MIL-F-70807 (AR)
AMENDMENT 4
15 March 1991
SUPERSEDING
AMENDMENT 3
23 February 1990

MILITARY SPECIFICATION

FUZE, PD: M745
(LESS BOOSTER AND LEAD)

FIGURE 1

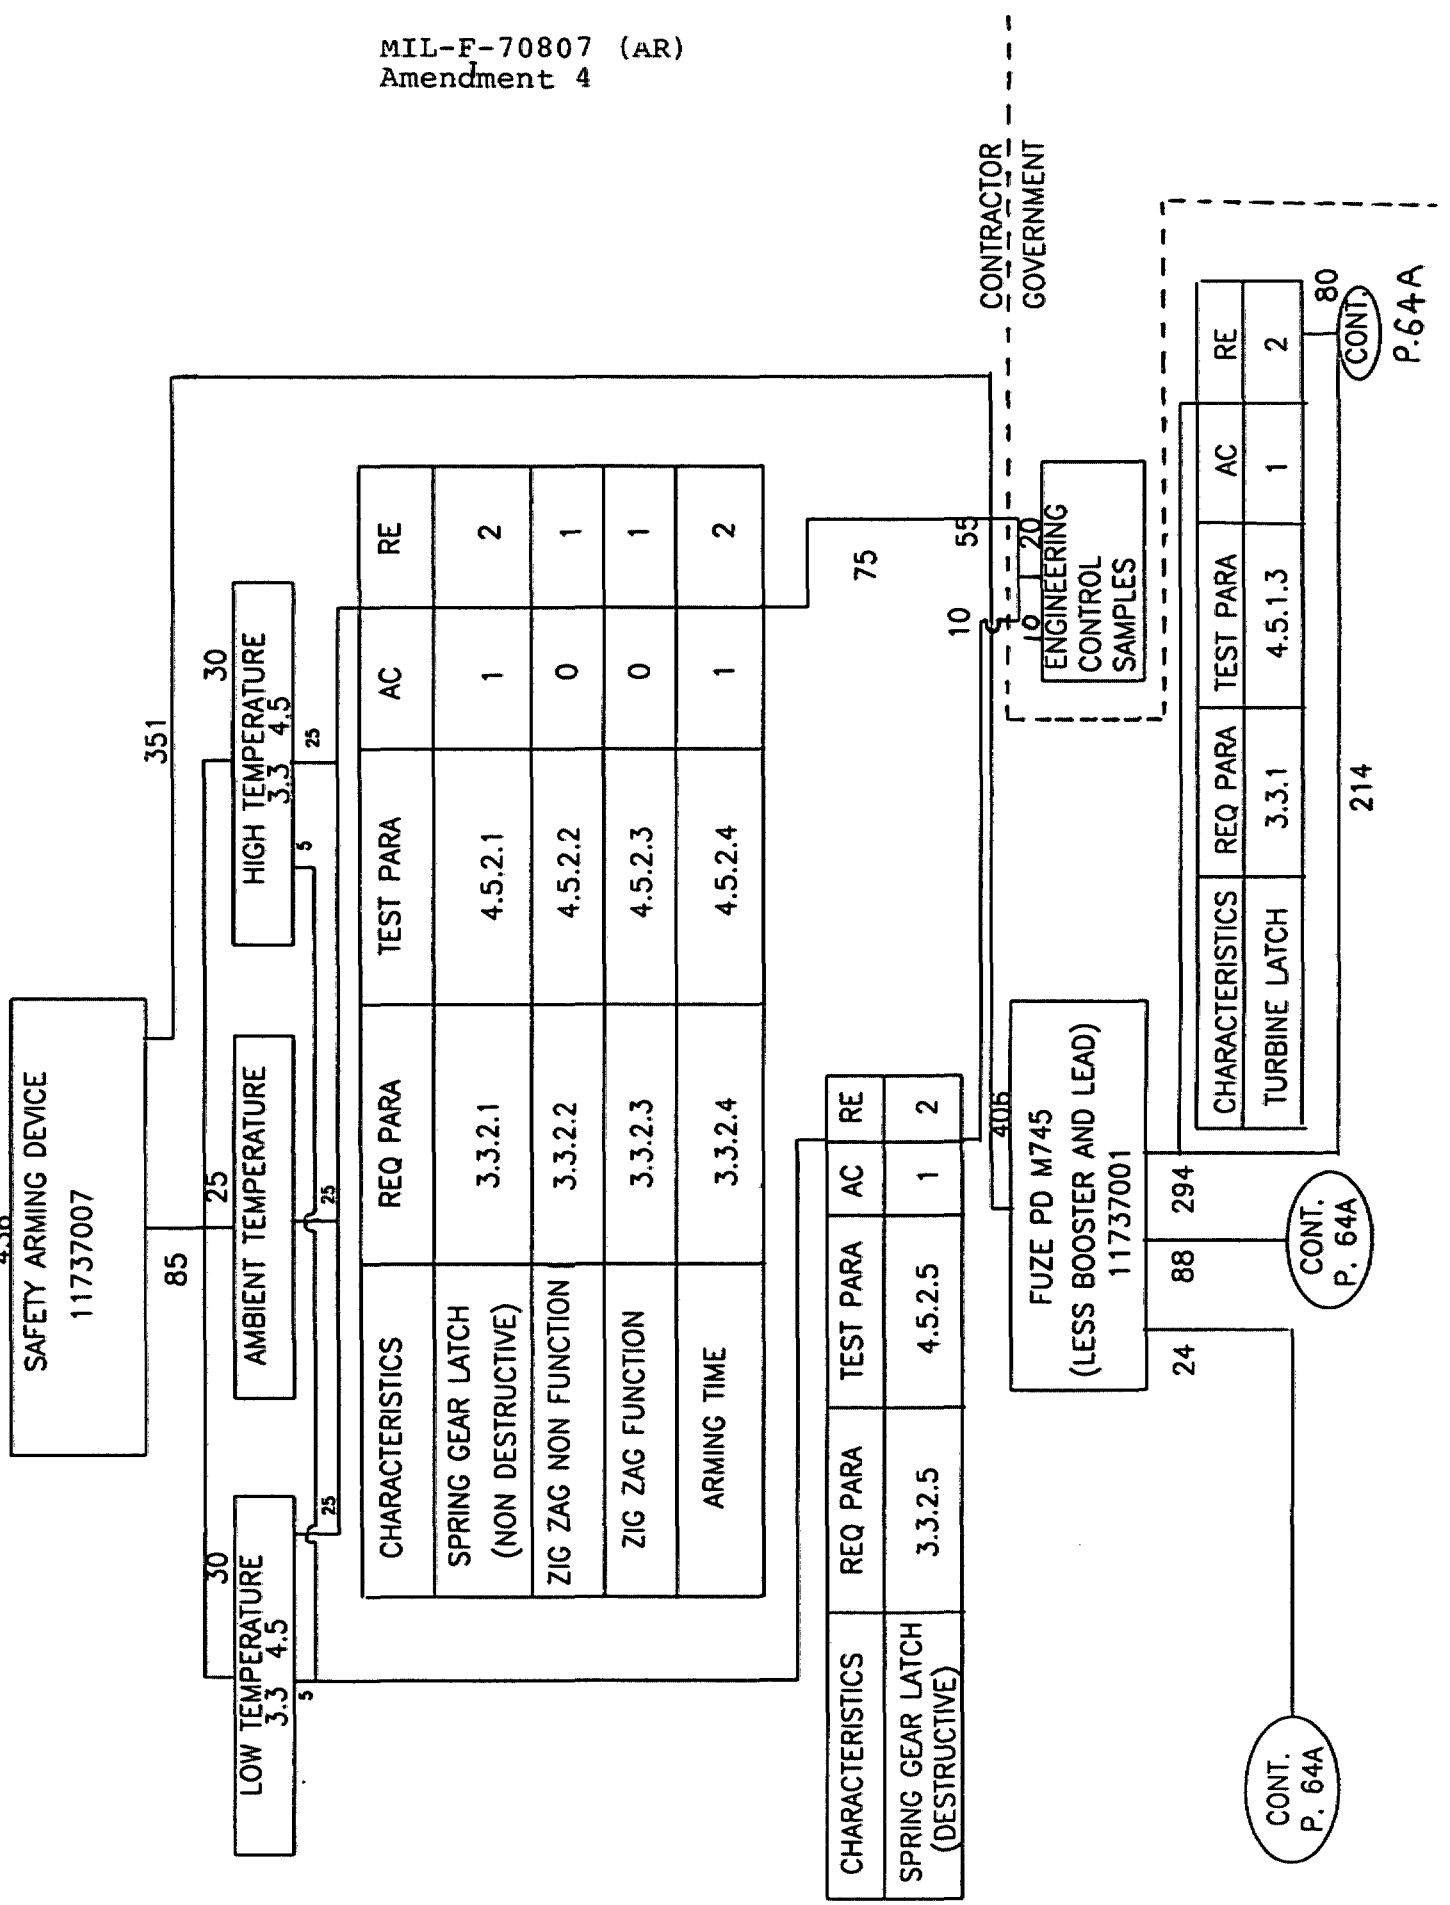
* Change Duds "3/4" to "6/7"

FIGURE 2

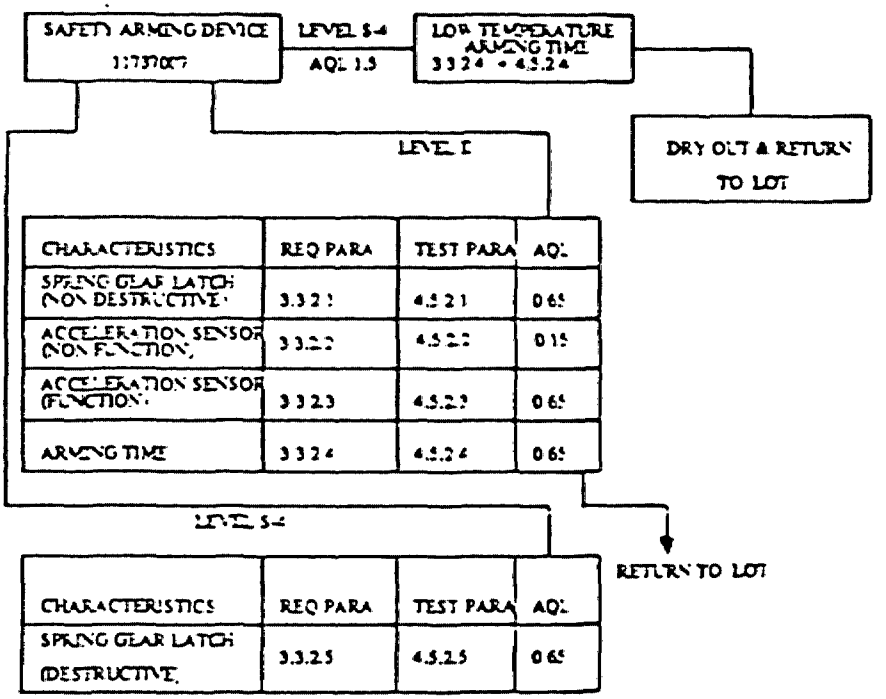
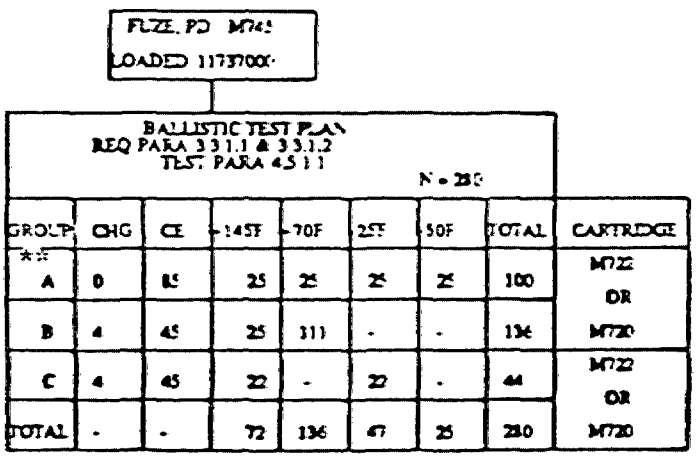
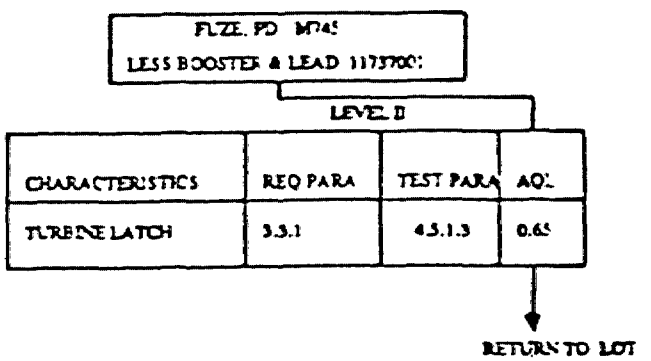
3.1.4.1 Initial production lot. Select at random ballistic lot acceptance samples from first production lot. Ballistic lot acceptance test plan is shown in figure 2.

4.4.3.1: Change "Figure 2" to read Figure 2 and 3."

4.4.3.2: Change "Figure 2" to read "Figure 2 and 3."

FIGURE 3

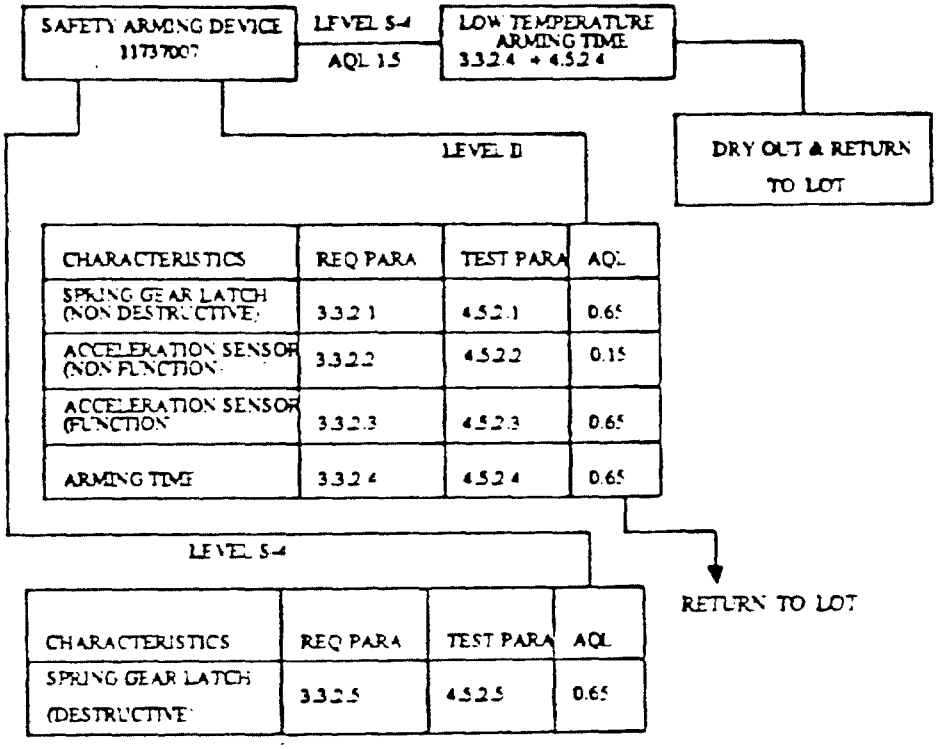
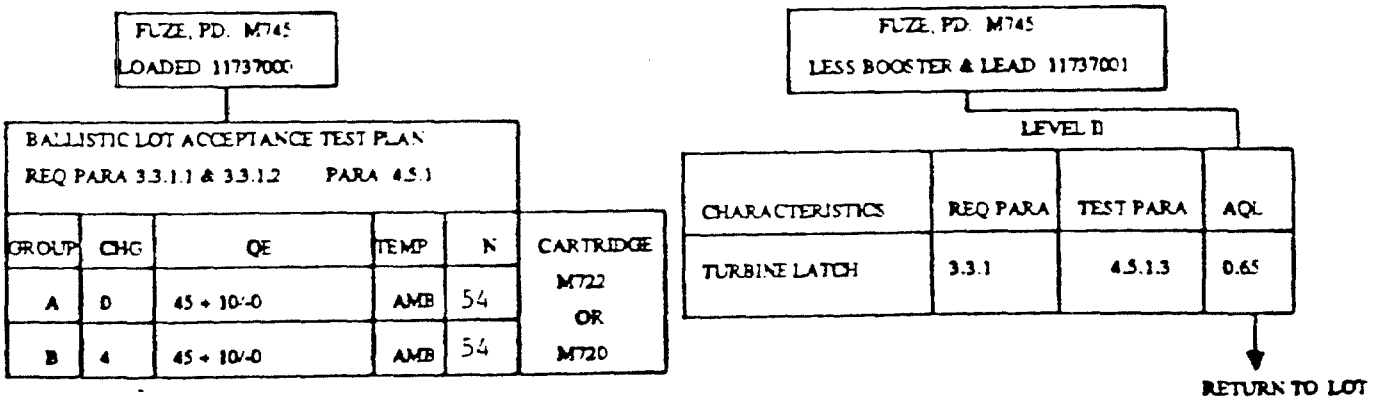
3.1.4.2 Production lot. Select at random ballistic lot acceptance samples from each production lot. Ballistic lot acceptance test plan is shown in figure 3."

FIGURE 4 INTERFACE CONTROL DRAWING

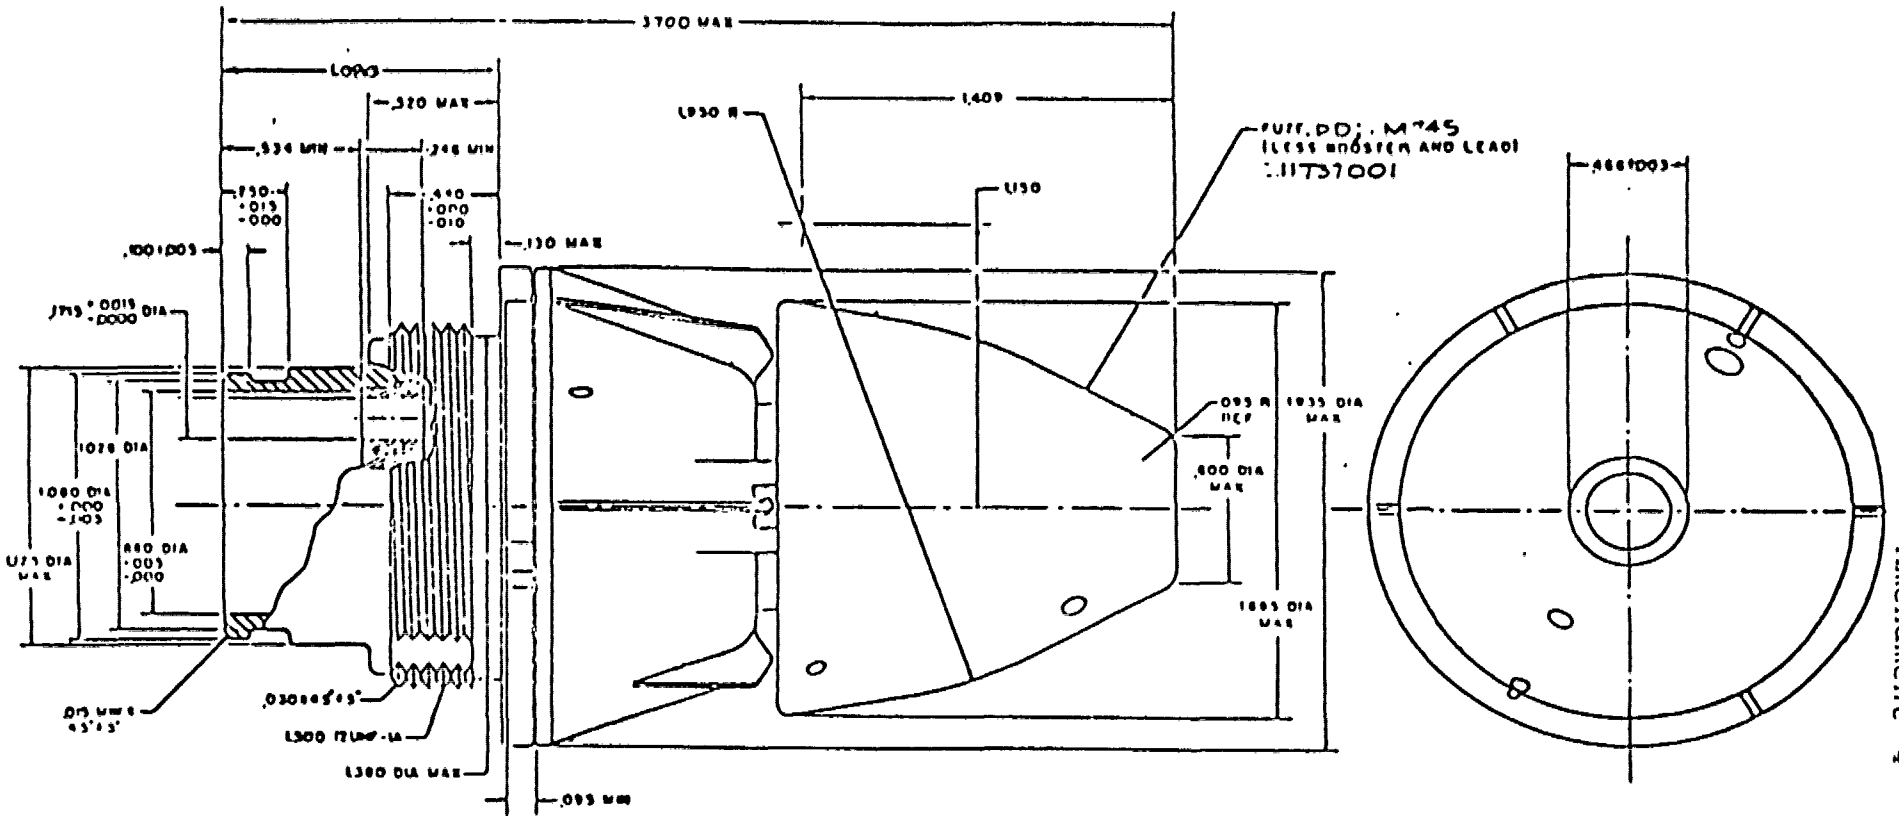
3.2: Change "(Figure 3)" to read "(Figure 4)."

Figure 4: Add new figure per included sheet.
